NEW AFAM CHAIN

PRODUCT INFORMATION

AFAM A520MX6 CHAIN

NEW A520MX6

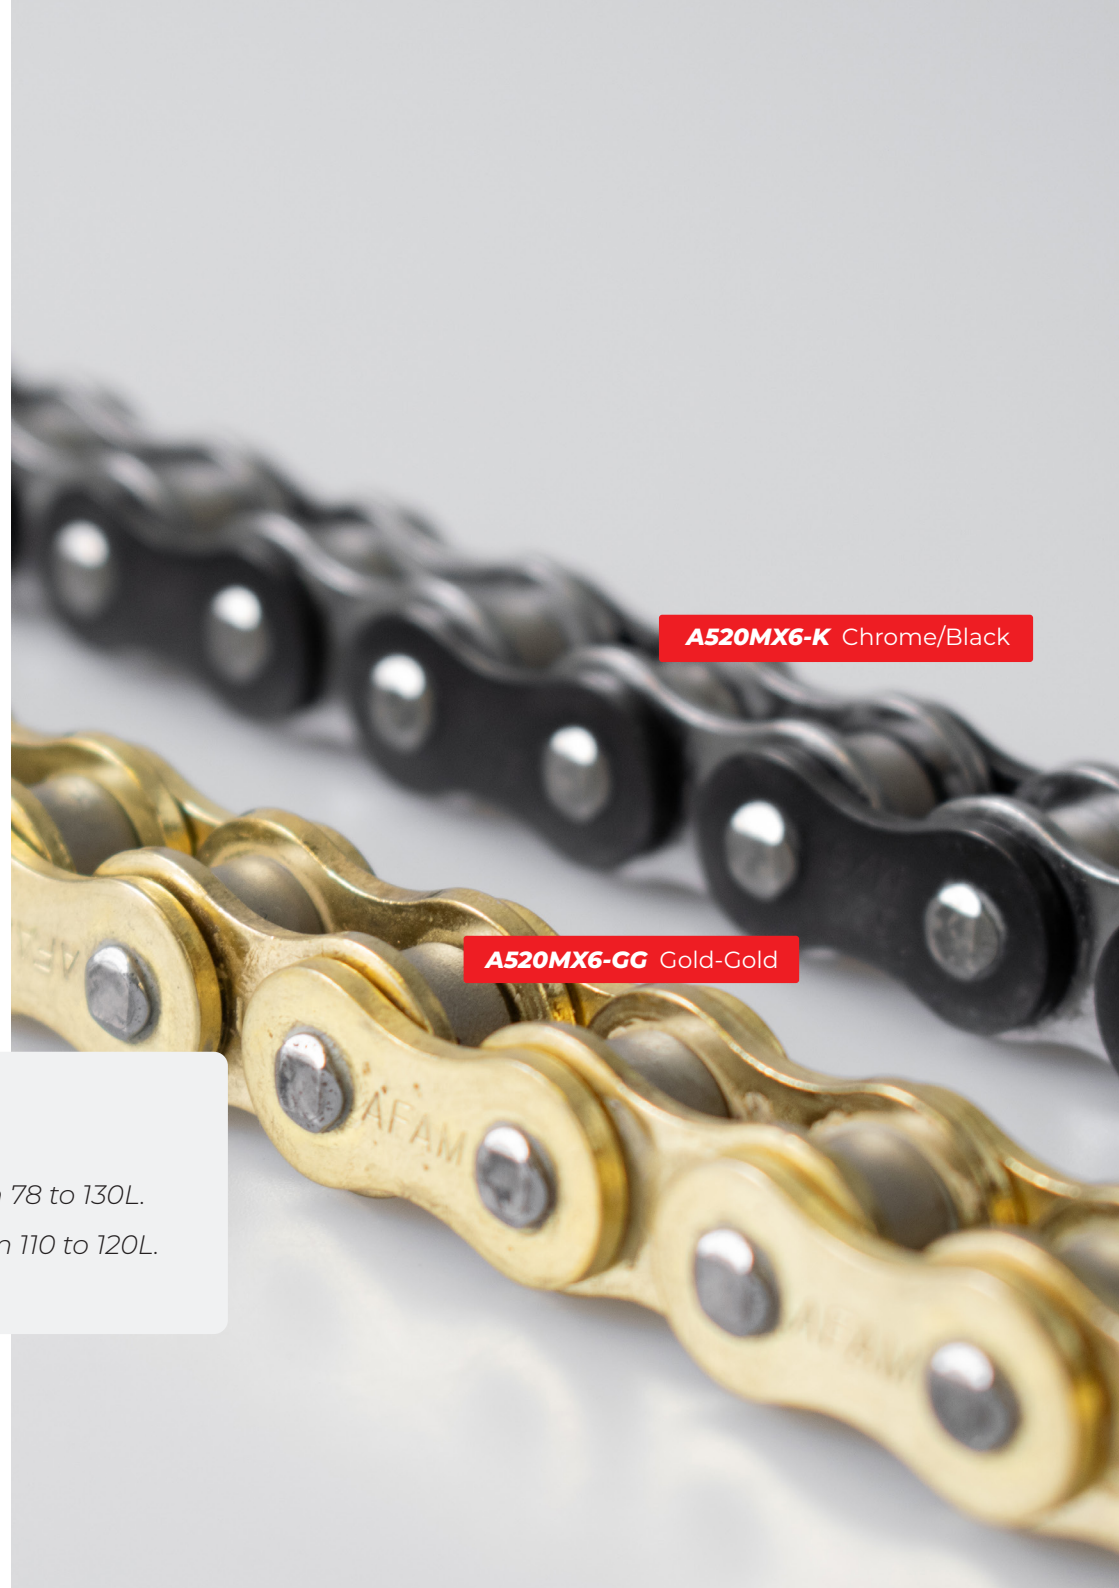
As you know, we are constantly looking for ways to improve our products, in this regard we have developed a new MX chain: A520MX6.

This chain will replace the A520MX5-G.

Apart from the look,
3 major improvements have been made:

- Increase of the Push out Force between the pins and the outer plates.
- Increase of the Push out Force between the bushes and the inner plates. These 2 elements will limit in a very important way the phenomena of hard points on your chain and what will allow you to keep a very good flexibility throughout the use.
- The most significant improvement is the increase of the fatigue strength, we have increased it by about 20% compared to the A520MX5, this means that your chain will stretch less and less quickly.
